Notice of Allowability	Application No.	Applicant(s)
	10/791,581	LIANG, GEORGE
	Examiner Richard Edgar	Art Unit 3745

FIG. 2

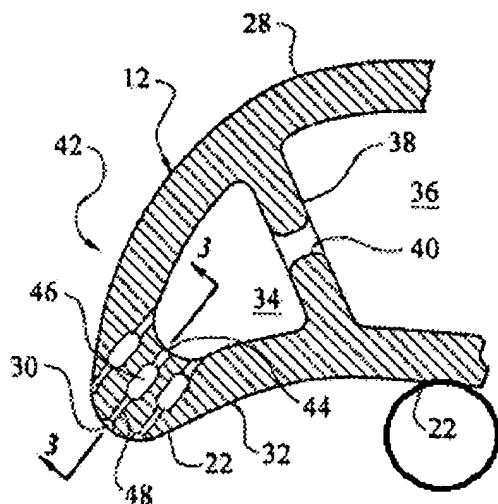
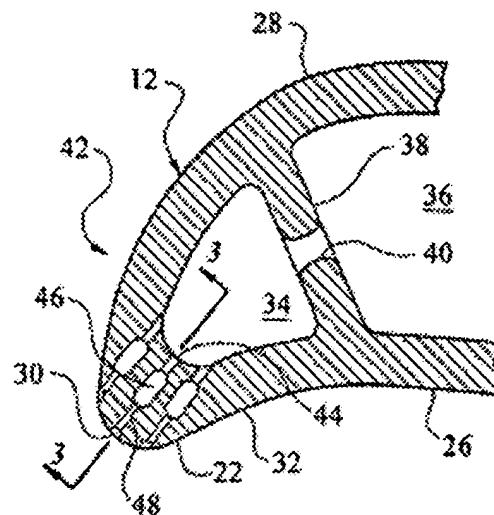
The numeral "22" in Fig. 2 should be -- 26 --. See reproduced figures below wherein the drawing on the left identifies the error and the drawing on the right shows the correction. In order to avoid abandonment of the application, applicant must make this drawing change.
